STAFF REPORT: MARCH 8, 2023 MEETING

APPLICATION NUMBER: 22-8197

ADDRESS: 15083 MINOCK

SCOPE: DEMOLISH GARAGE*, ERECT GARAGE, DEMOLISH ADDITION, ERECT ADDITION AND DECK, INSTALL VINYL WINDOWS

Applicant drawing – side/north elevation

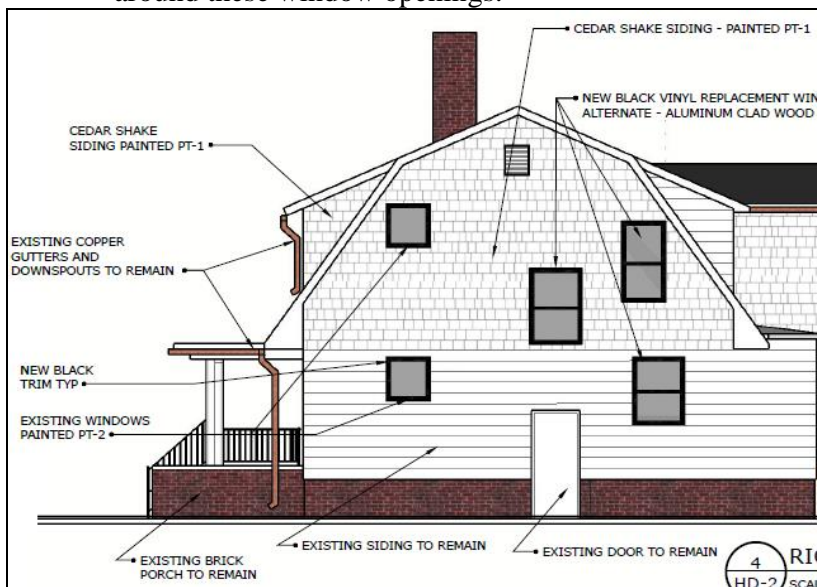
The designation photo shows what is likely the original casings/framing around the windows. The wood had a flat profile; the horizontal header is wider than the vertical members, and the bottom sill was very thin in height and extended outward from the vertical framing.

The clarity of the historic and current images isn't ideal; however, it still appears to staff that the existing framing is very similar in dimension to what is shown in the designation image, and a narrow, protruding sill is evident. Therefore, staff believes the historic wood casings remain in place and should be retained for the upper and lower window openings, including the mullion remaining within the first floor opening (visible in top right photo). The trim choices offered by Anderson: flat and profiled casings, brick mould casings and sill nose (metal and wood) should not be selected as none of these options match the historic/existing conditions.

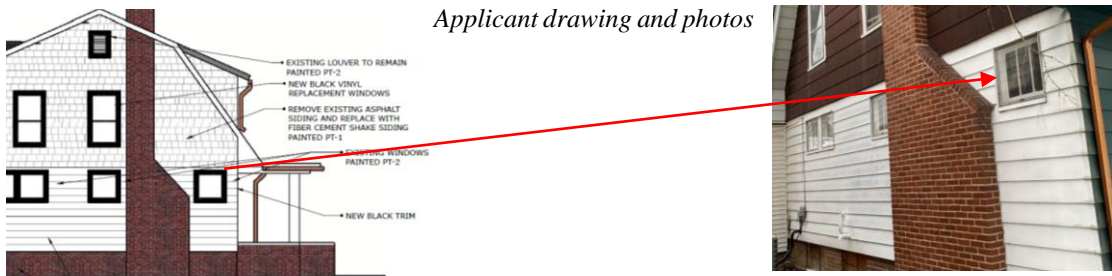
- Staff does not know if the side and rear elevation vinyl windows were in place prior to the district’s designation, however the applicant proposes to replace the vinyl units as part of this application. The applicant’s first choice of window sash for the addition and the existing side elevation windows on the house is JELD-WEN V-4500 vinyl frames, an alternate selection of Anderson E series is noted on the elevation drawings.

- Staff believes the commonality of materials between the addition and house should include the window openings. (Example: The applicant has proposed wood shake siding at the second floor on the house and addition.) It is highly probable the sash dimensions (top/meeting/bottom rails and stiles) of the JELD-WEN units will not match the dimensions of the Anderson E-series. Additional details such as finishes for energy efficient glass could further differentiate the appearance of replacement windows fabricated by different manufacturers.

- The proposal states the aluminum siding will be cut back for the installation of vinyl trim/window casings for the first floor windows, and existing wood trim at all second floor openings will be covered. As mentioned on page 4, staff believes the original wood window casings remain exposed at second floor front elevation and at the side elevations. Vinyl trim should not cover original window casings. Rather than cutting back the aluminum siding to install vinyl trim, the aluminum should be cut back to expose the existing wood casings. Additionally, there is inadequate room at the chimney on the south elevation to install additional window trim.

- Anderson E-series double-hung units will be selected for the house. Full divided light or simulated divided light grilles will be selected; the width will be 5/8", and have the ovolo profile.
- A mocked-up photograph of the front porch, showing where the new railing will be installed, and a description stated that the new railing will match the historic railing in material, color, dimension, and design, shall be submitted for staff review.

Drawing from current March 2023 application

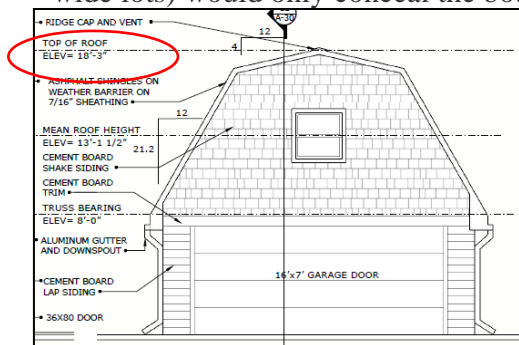
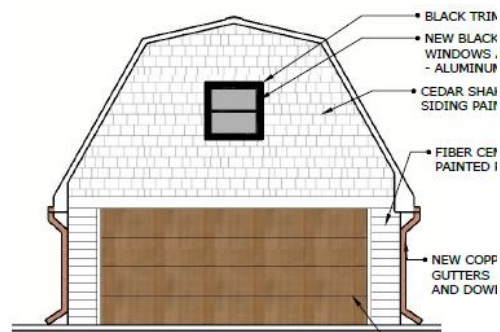
- The applicant removed the notation of a second floor on the garage plans; however, the sizing/height of the garage was not reduced.

Above, top, and bottom right: applicant drawings and photo; middle right: staff photo

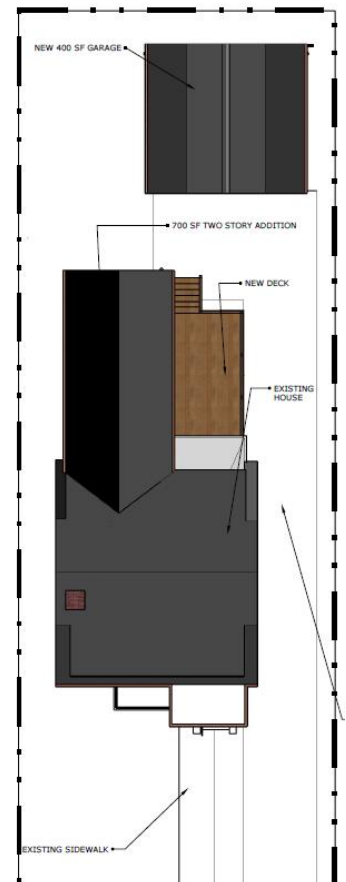
- The addition's southern elevation (shown below) has mostly double-hung windows, but one smaller horizontal window remains. The existing small windows on the house (which the applicant will retain) are located on both sides of the house; the north elevation has one small window at the second floor. All of the double-hung windows on the sides and rear have, and are proposed to have, one one-over-one sash.

Applicant drawings and photographs. The applicant’s photo is taken from the location of the proposed garage. A star denotes the location of the proposed deck.

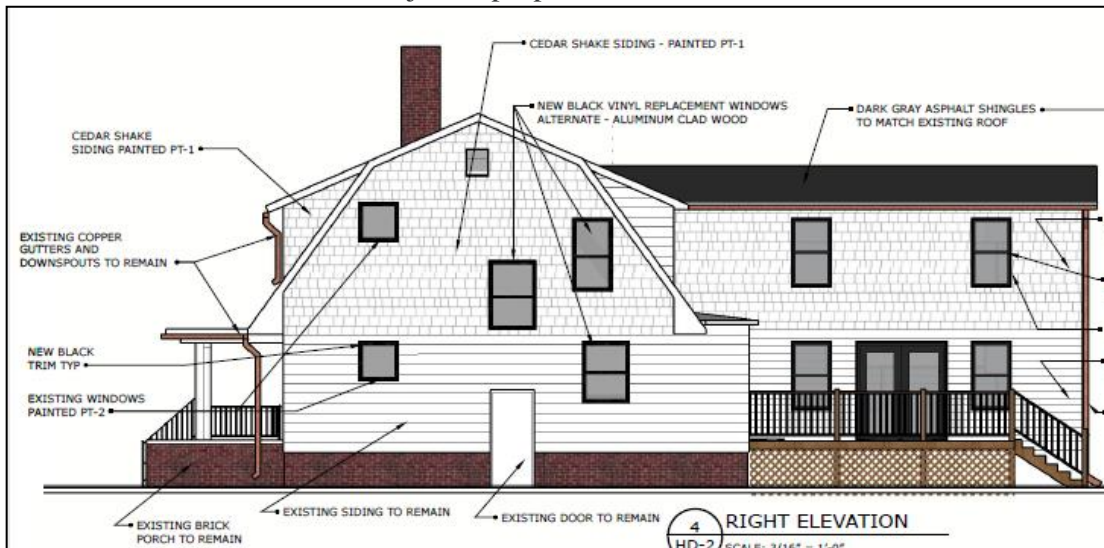
- The term “moderately scaled dwellings” is referenced in multiple elements of design. As staff mentioned with the garage, a two-story addition extending almost 29’ back from the house will create a large impact on the neighboring lots.

- Staff isn’t opposed to the erection of an addition or a 20’ x 20’ garage, rather the main opposition is over the scale of each structure. Additions extending from the rear elevation are very common, however they often have flat or low slope shed roofs starting at/near the house’s eave. An addition should also not have a larger footprint than the house (whether in direct length or overall square footage). Just as the width of the proposed addition is about half the width of the house, the addition’s length should be at most half of the existing house’s length. Therefore, all elevations would be more proportional to the house, lot, and adjacent properties.
